IN THE DRAWINGS

REMARKS

Applicants for Intel Corporation

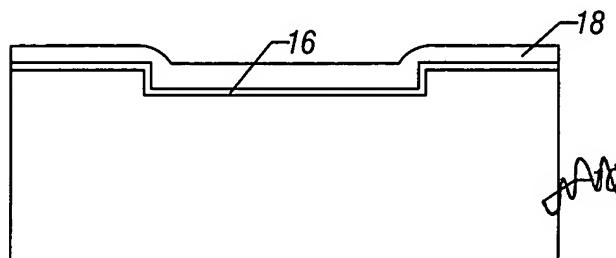
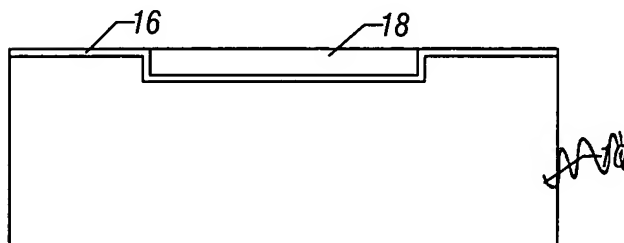
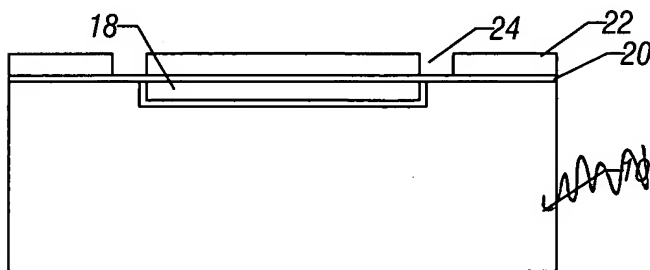
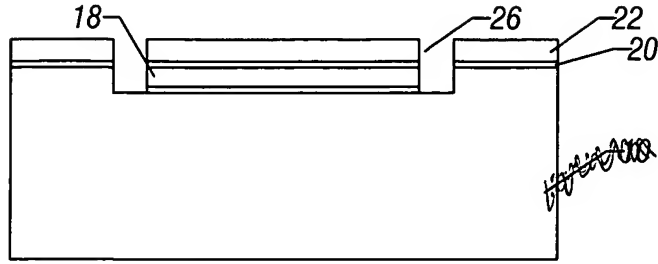
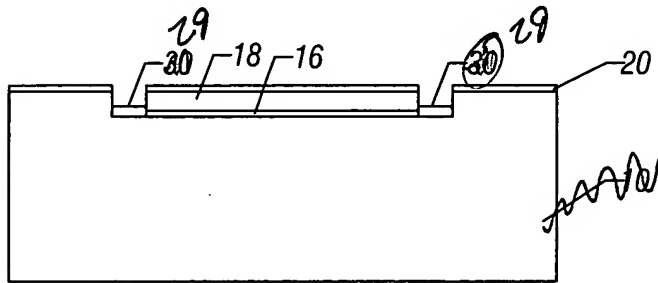
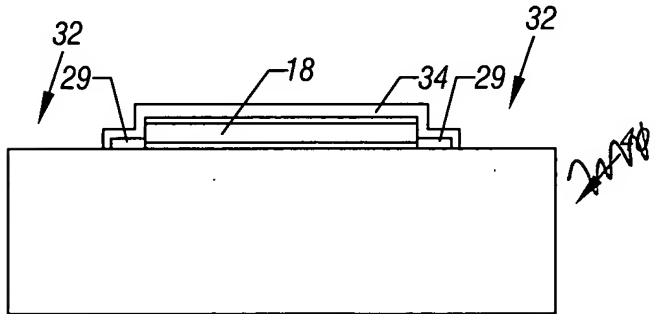
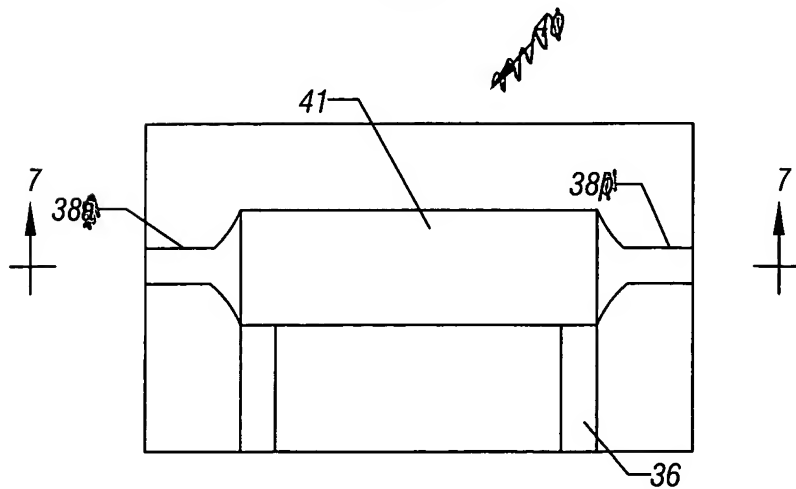
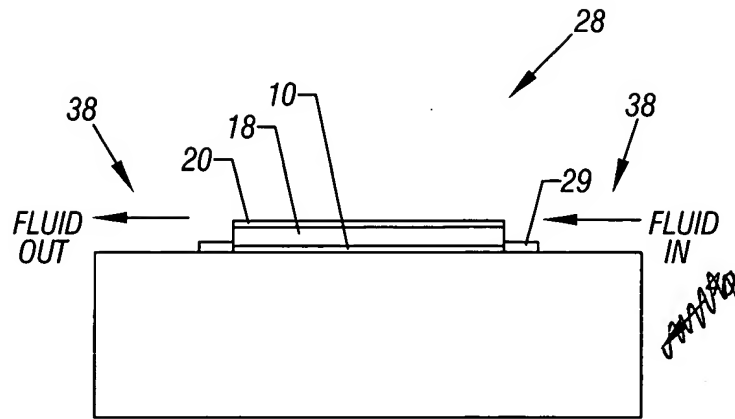
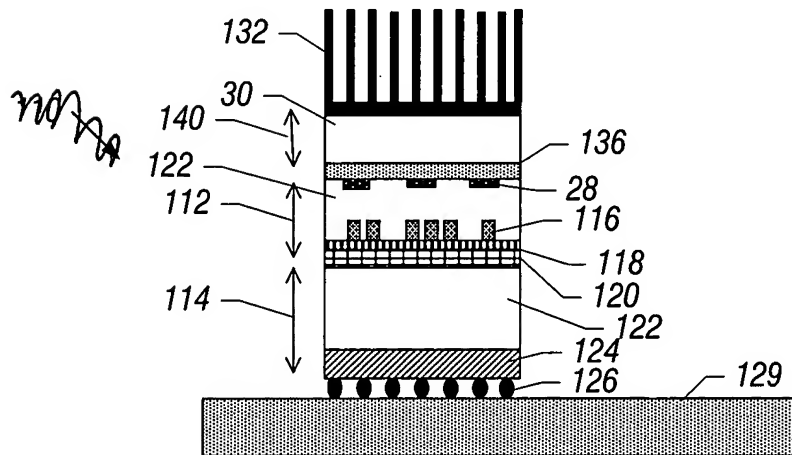
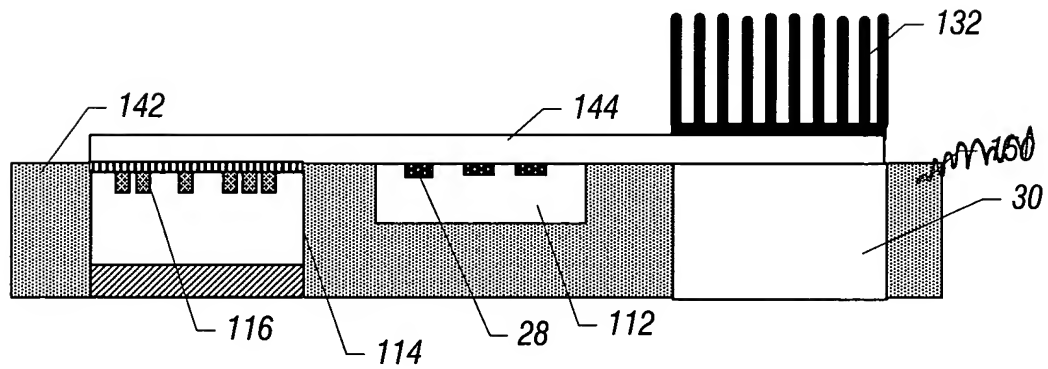
Figures 2-9, 19, and 23 have been amended as indicated in red in the attached annotated marked-up drawings. Replacement sheets of Figures 2-9, 19, and 23 are also attached.

With respect to subparagraph (B), the reference numerals 10 and 40 have been removed from the drawings, the reference numerals 38a and 38b have been changed to 38, and the reference numeral 110 and the reference numeral 150 have been removed.
